SERVICE INSTRUCTION

Important notes for installing the ball bearing into the gearbox of ROTAX® Engine Type 912 i, 912 and 914 (Series)

ATA System: 72-00-00 Engine

Fig. 1

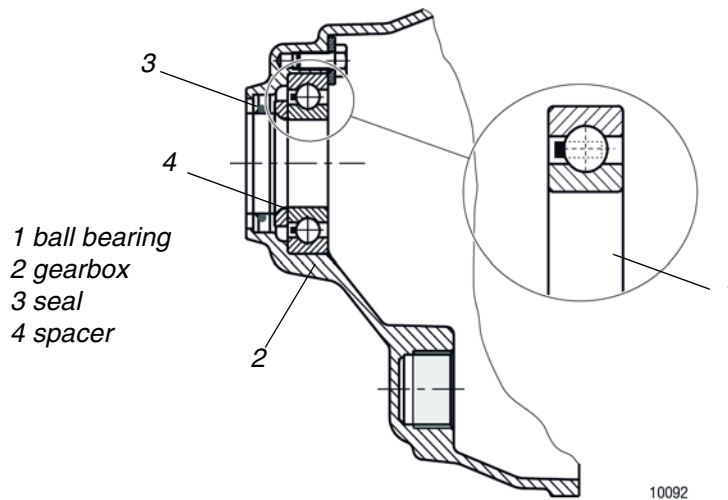
Information from the field has shown that in the course of repair or maintenance, the installation of the ball bearing was not carried out properly and also has not been instructed accordingly. Specifically, the ball bearing cage (plastic ball retainer) should be facing towards the propeller. This document should eliminate uncertainties of the corresponding installation position.

The following figure shows the correct installation position of the ball bearing:

“Closed” plastic cage.
Must be placed towards the propeller flange.

“Open ball” side must be towards engine.

Make sure that the cover plate is inserted between the ball bearing and the oil seal and/or the bearing balls are visible during installation.
